## ADDENDUM NO. 1

December 8, 2025

TANG HALL LABORATORY  
FIT-OUT

# A-910R

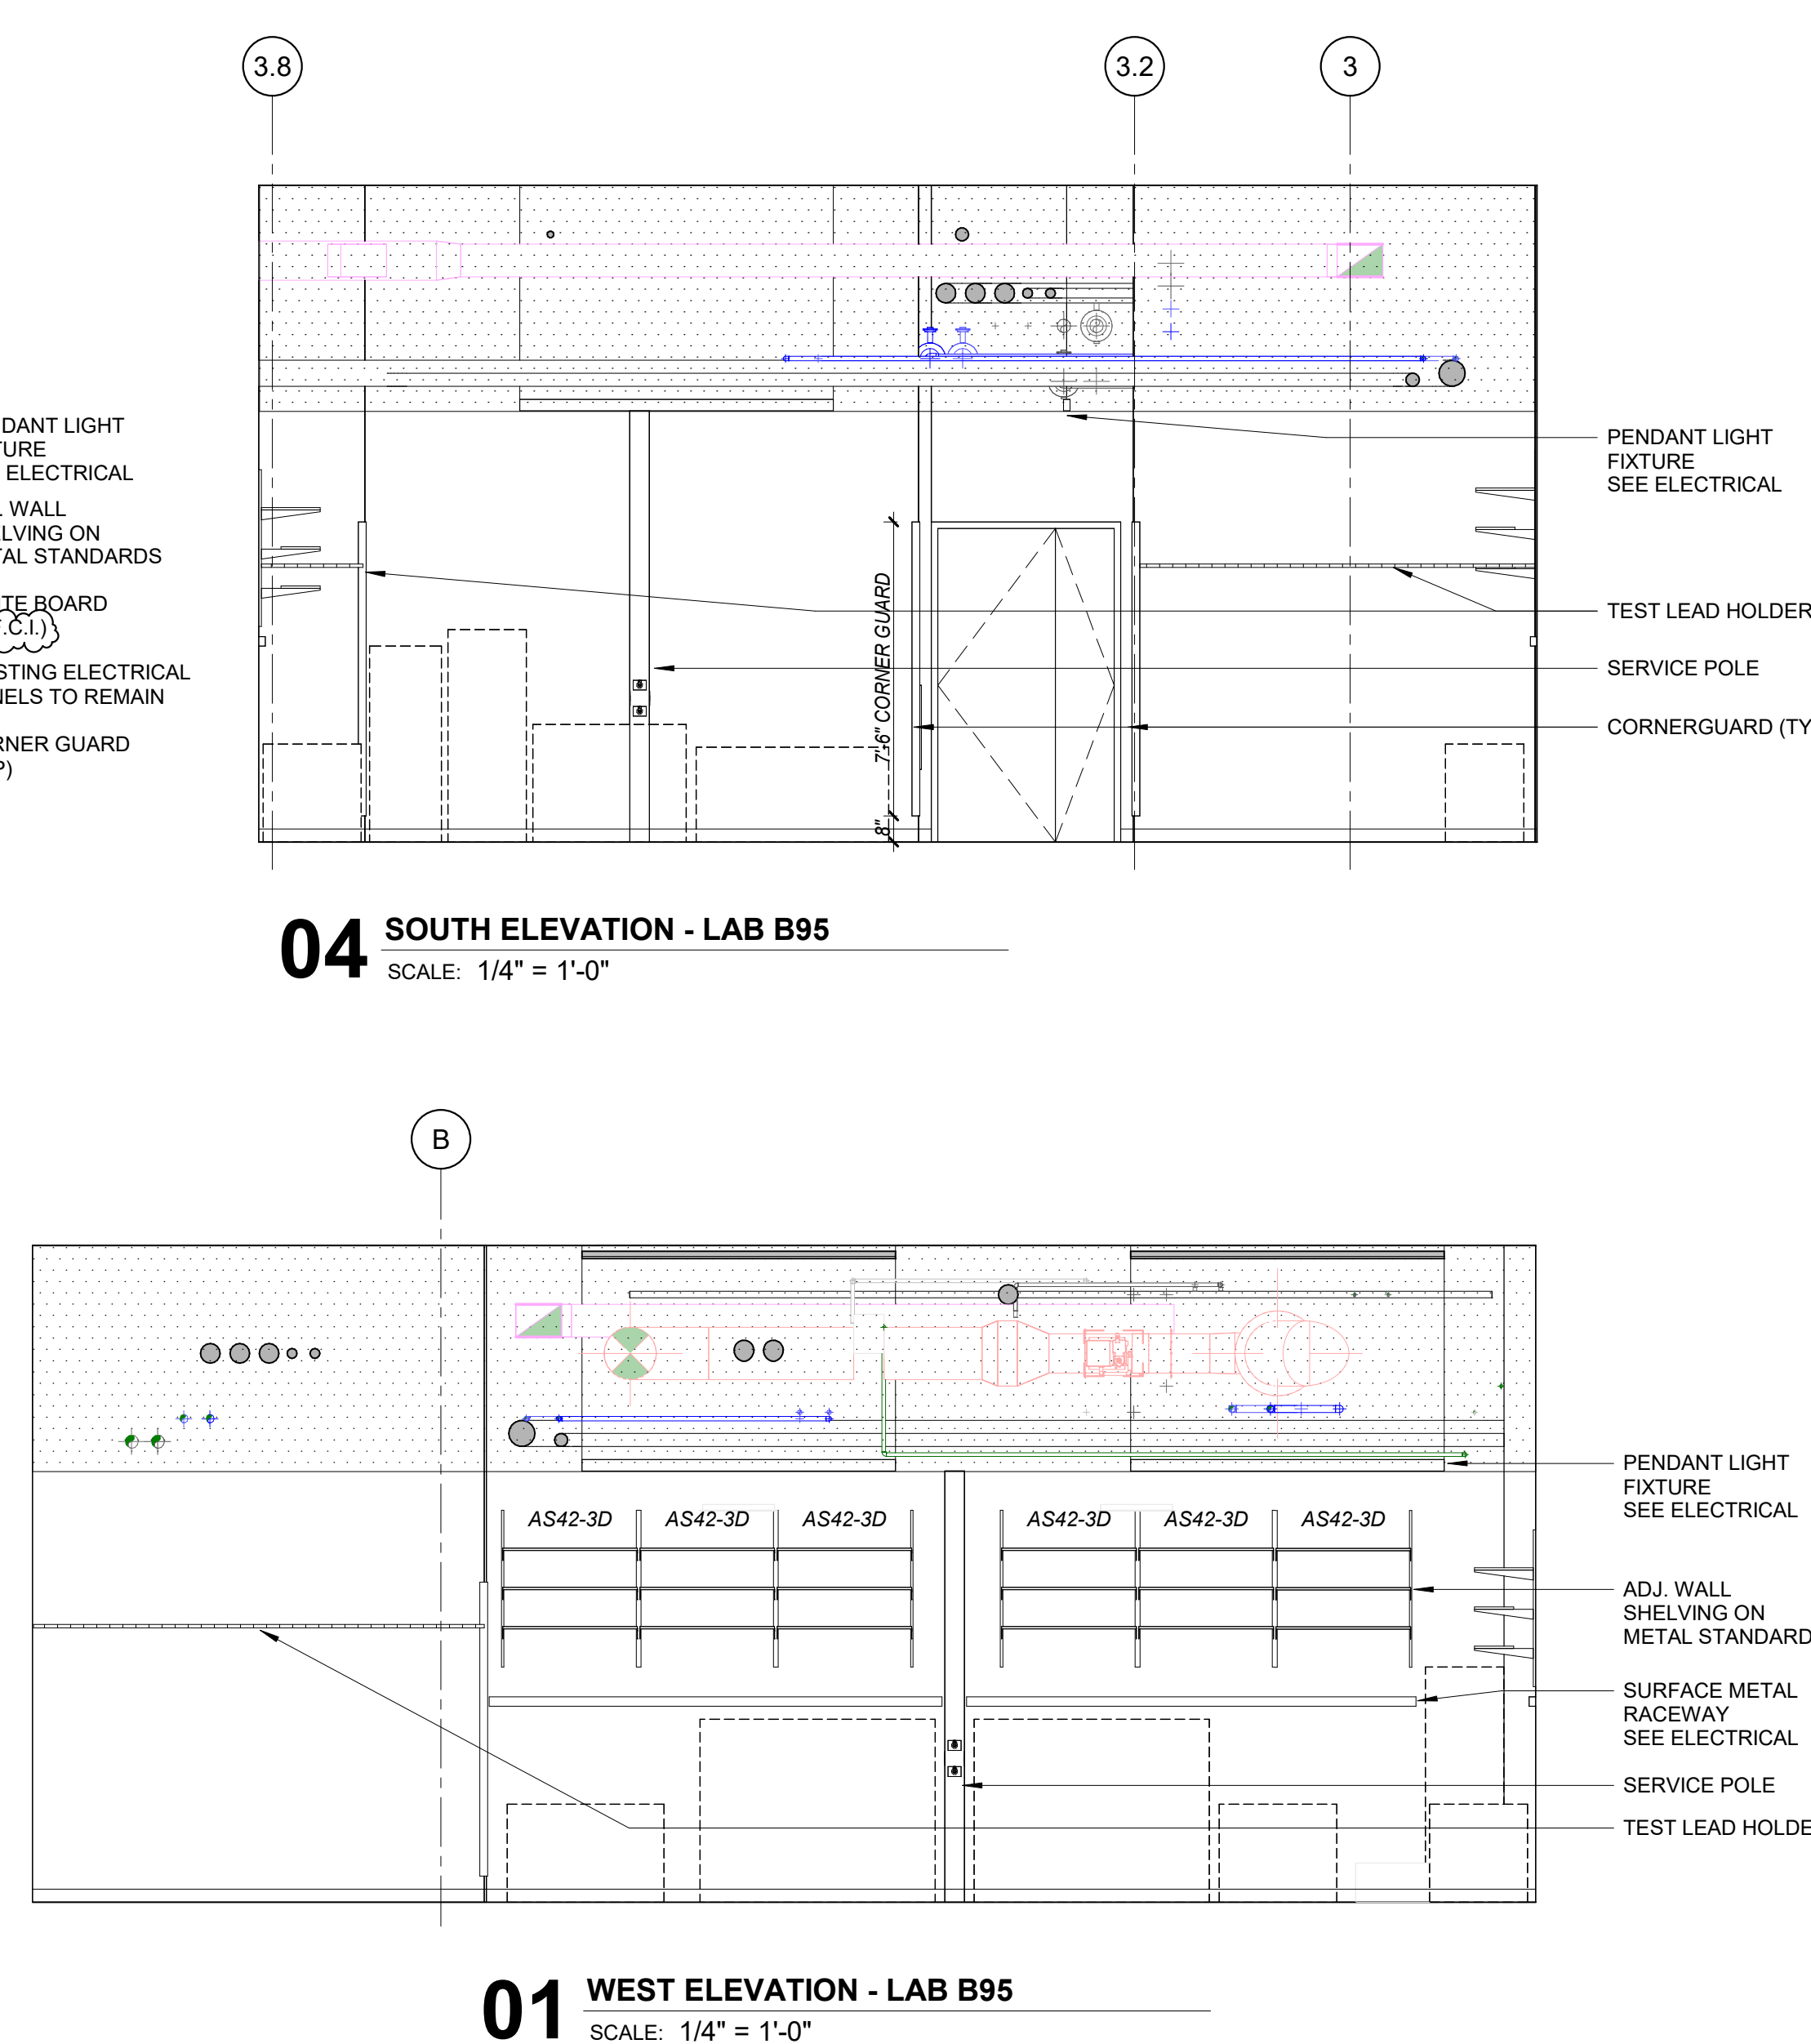
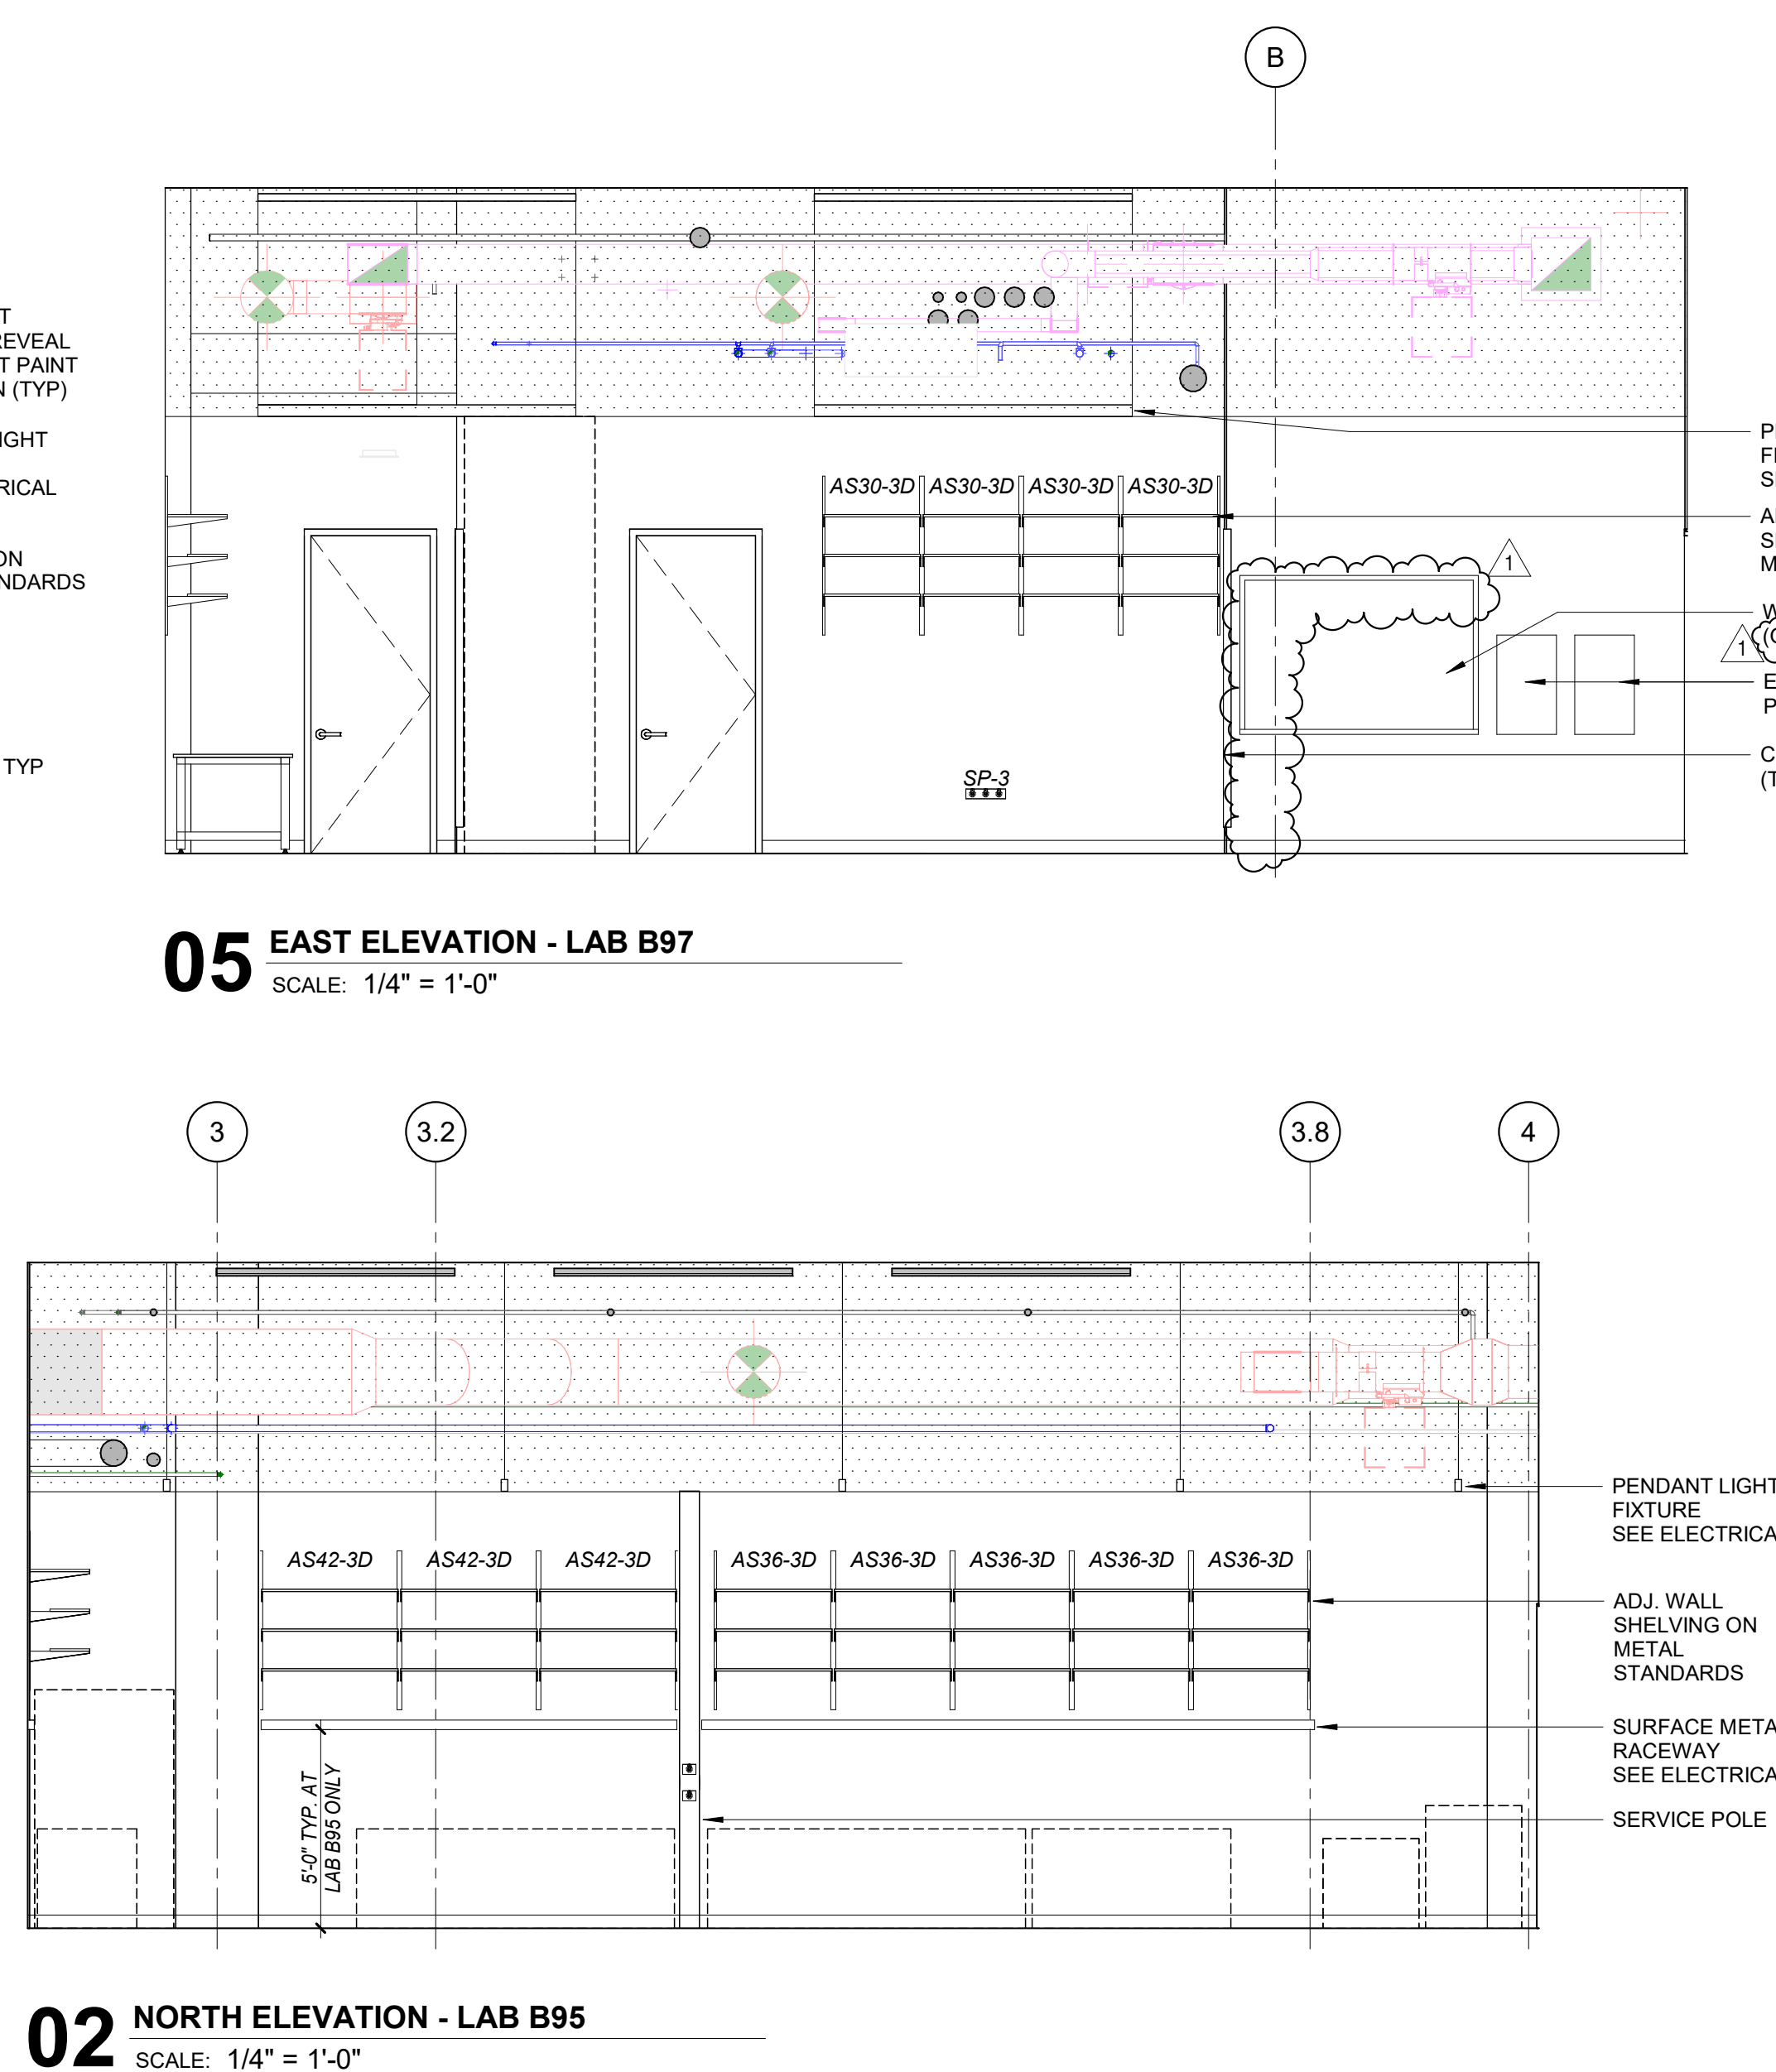
**DELETE** premix gas turret at wall. See Item 13 for reference.

Item 16. Drawing A-910R, all lab tables shown at Lab B97, B99 & B99B to match plan drawing

**REPLACE** notes in elevations to indicate all lab tables to be “**O.F.C.I.**” (Owner furnished, Contractor installed), to match plan drawing A-900.

Item 17. Drawing A-910R, whiteboards

**REPLACE** note in elevations to clarify whiteboards to be “**O.F.C.I.**” (Owner furnished, Contractor installed). See Item 12 for description.
